STAFF RECOMMENDATION 1304 Gartland Avenue January 17, 2018

Application: New construction—outbuilding/conversion to detached accessory dwelling unit; setback determination

Description of Project: Application is to convert an existing outbuilding to a DADU. The structure sits one foot (1') off the side property line, requiring a setback determination.

01 SITE PLAN - 1304 GARTLAND AVE
1" = 20'-0"

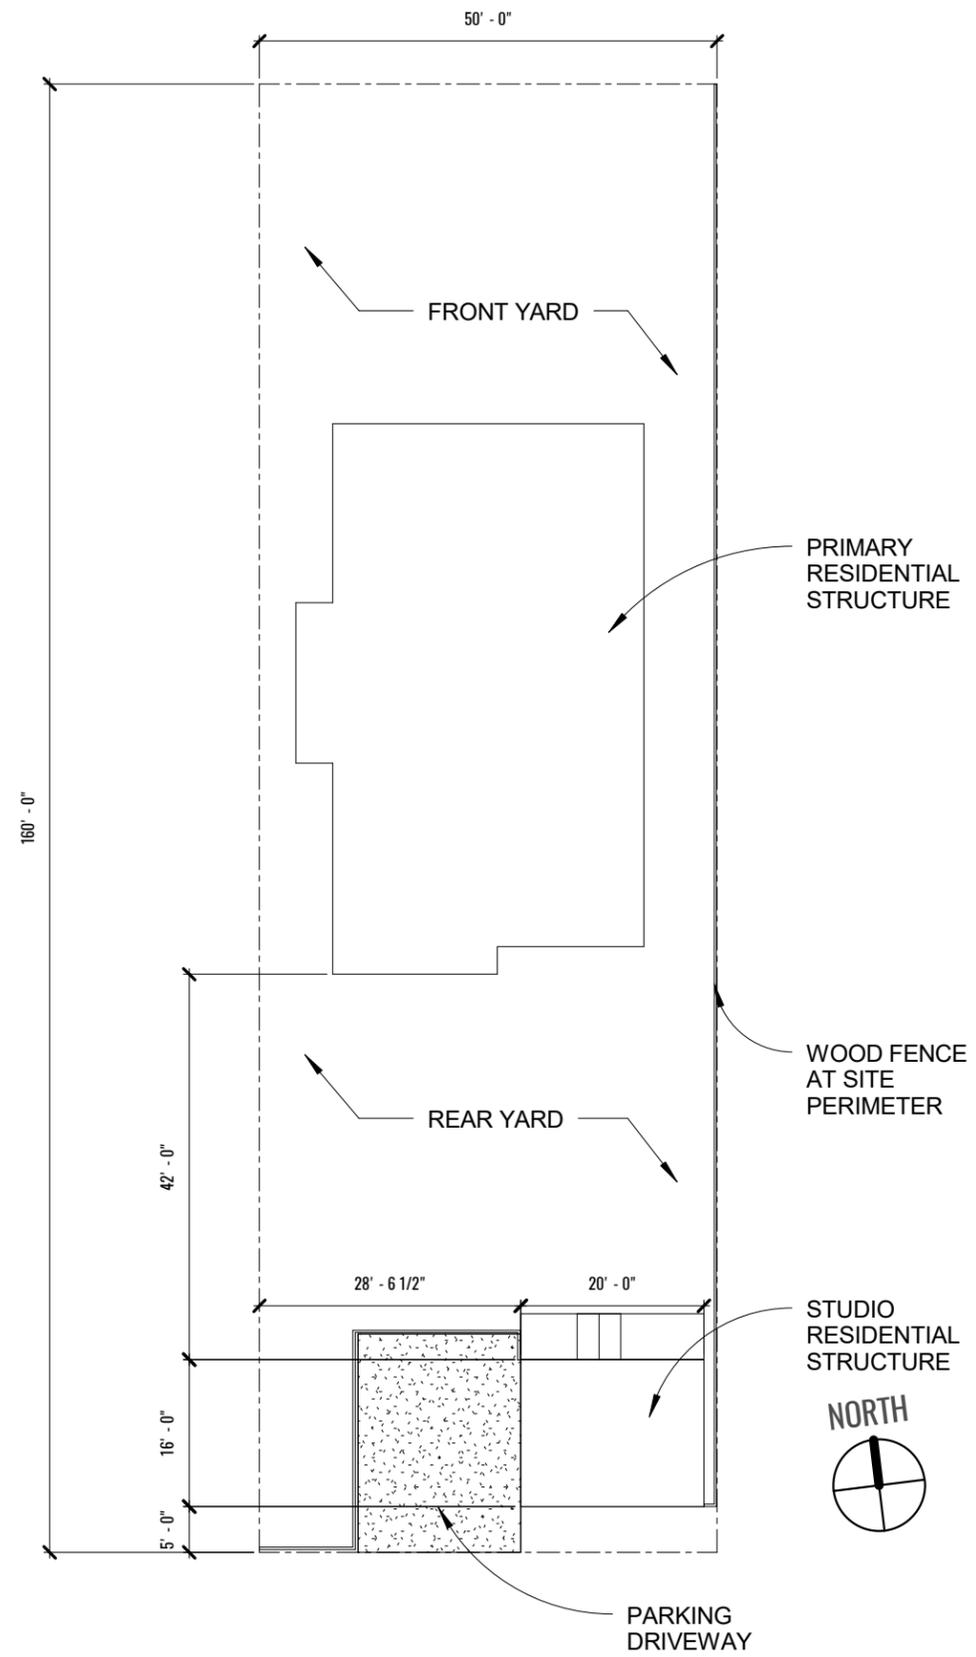
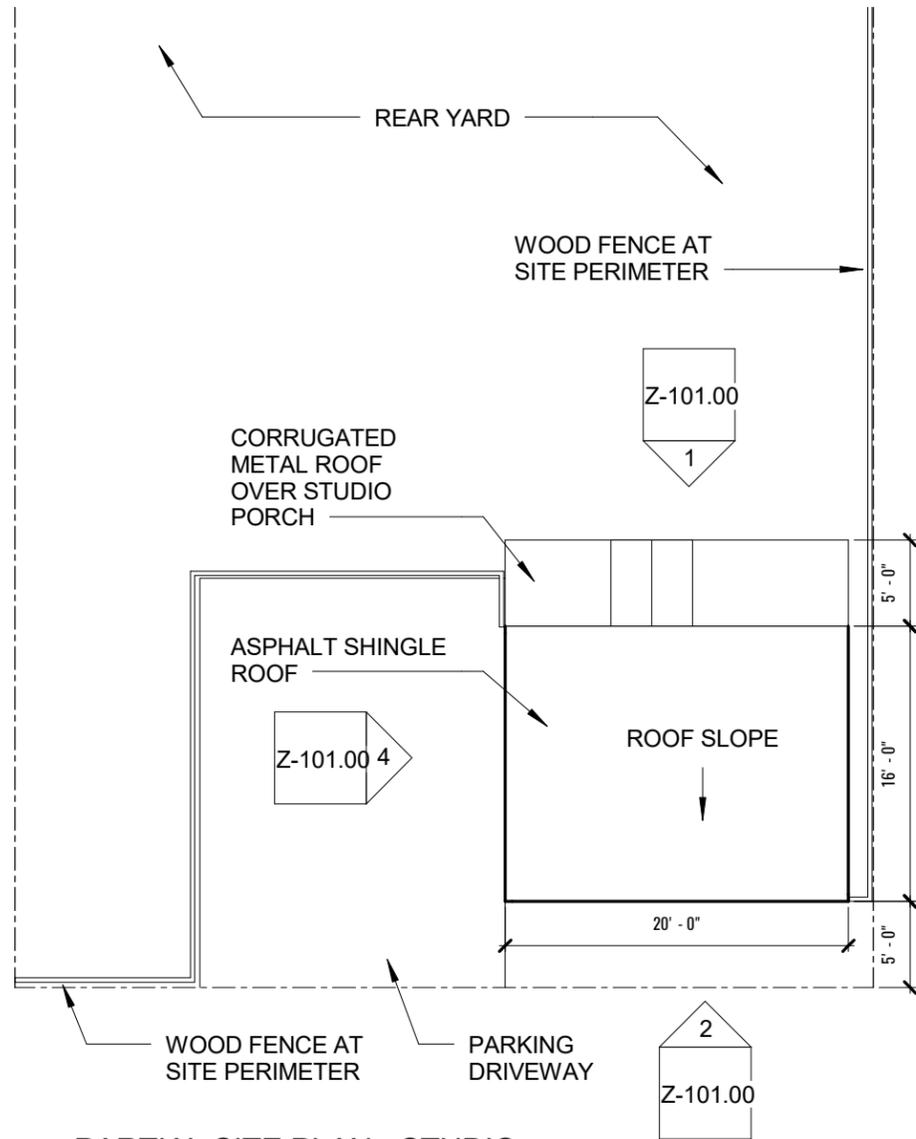
The structure sits forty-two feet (42') from the primary dwelling, five feet (5') from the rear property line, more than twenty-eight feet (28') from the west property line, which meets bulk standards and design requirements. However, the building sits only one foot (1') from the east property line, which does not meet the design guidelines for outbuildings, the ordinance for DADUs or bulk standards.

The project does not meet section II.B.8 of the design guidelines and 17.16.30.G. 4 of the ordinance.

ELEVATIONS

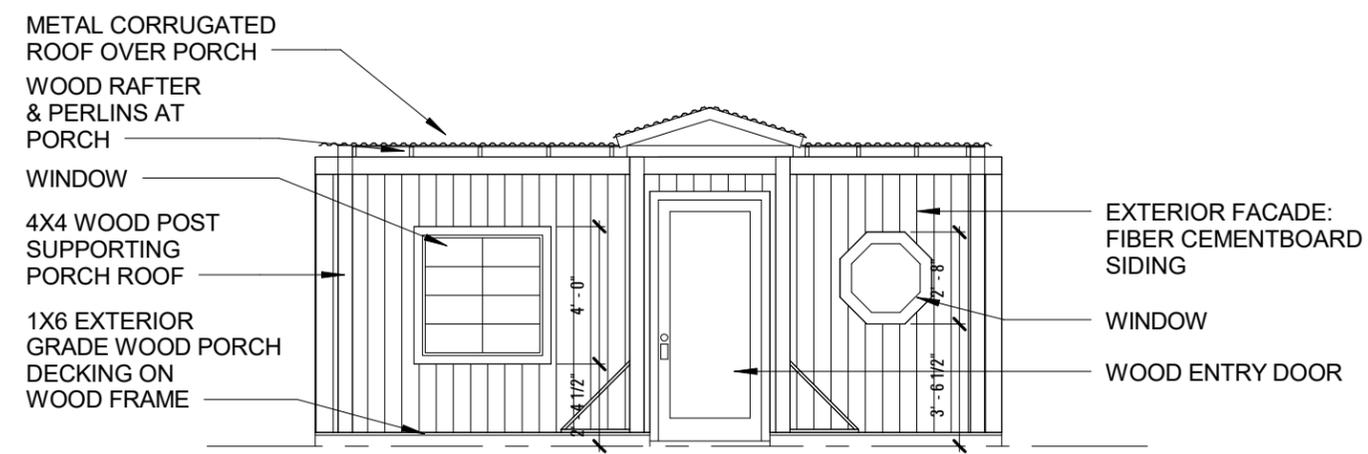
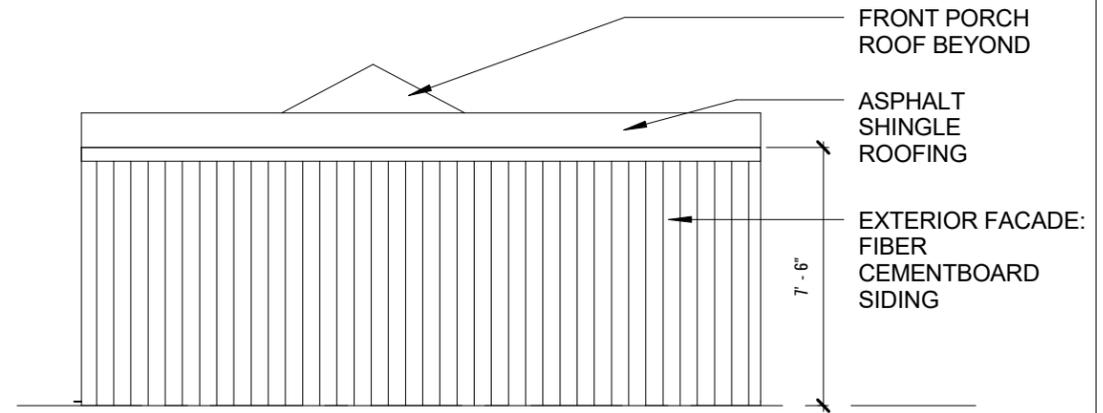
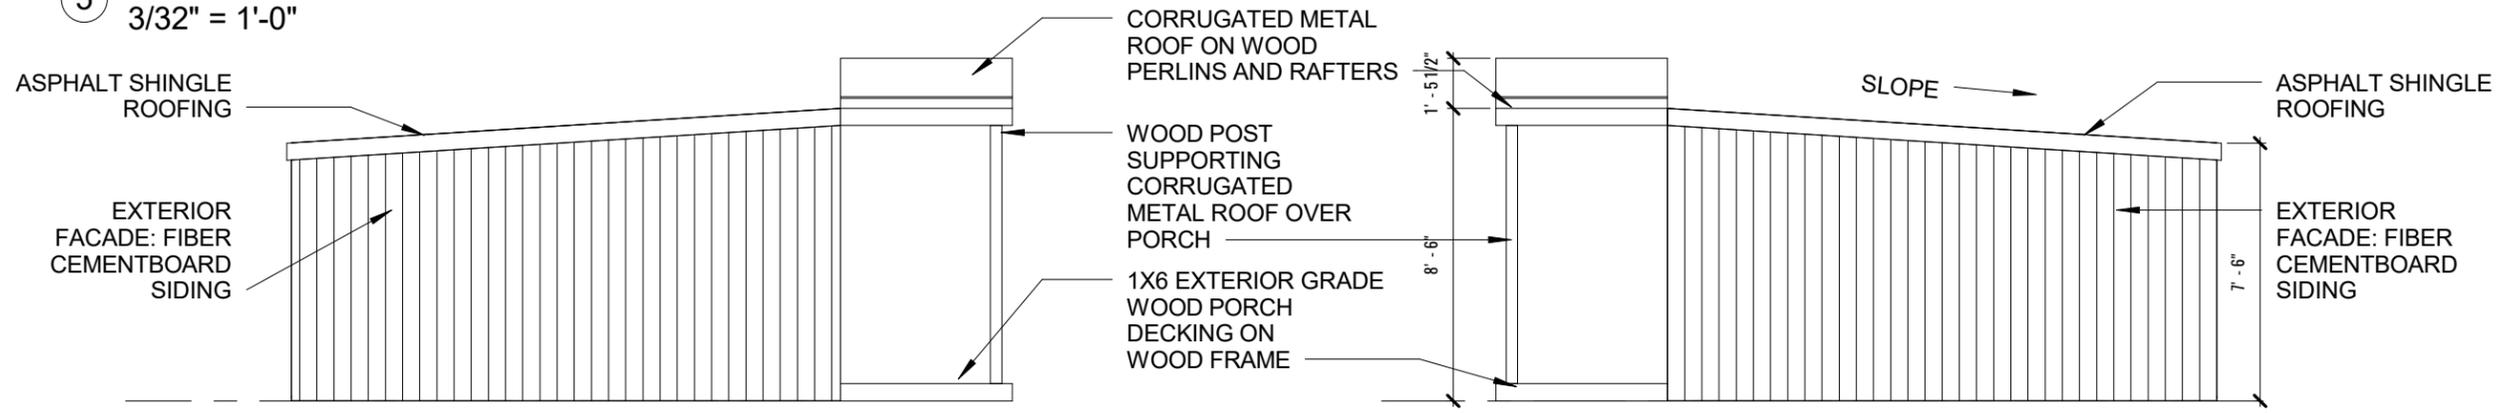
The roof form and slope are similar to historic outbuildings, however, the guidelines require at least a 4/12 roof pitch for DADUs. Staff finds that the project does not meet Section II.B.8.a of the design guidelines and section 17.16.030.G.8 of the ordinance.

(Please note that two of the materials are mislabeled on the drawings: the roofing is asphalt roll rather than asphalt shingle and the siding is T1-11 rather than cement board.) The existing materials are largely appropriate for an outbuilding in Lockeland Springs. However, the T1-11 cladding material is specifically listed in the design guidelines as an inappropriate material. Further, the windows are not approved windows. Window replacement alone is not reviewed in a conservation overlay, however, windows are reviewed for DADUs. Because of these non-approved materials, staff finds that the building does not meet Section II.B.8.a.

As described above, the roof pitch is approximately 1/12. While very low pitched roofs are fairly common on modest outbuildings, the guidelines require that DADUs have at least a 4/12 roof pitch. As such, the project does not meet section II.B.8.a of the design guidelines and sections 17.16.30.G.5, 8 and 9 of the ordinance.
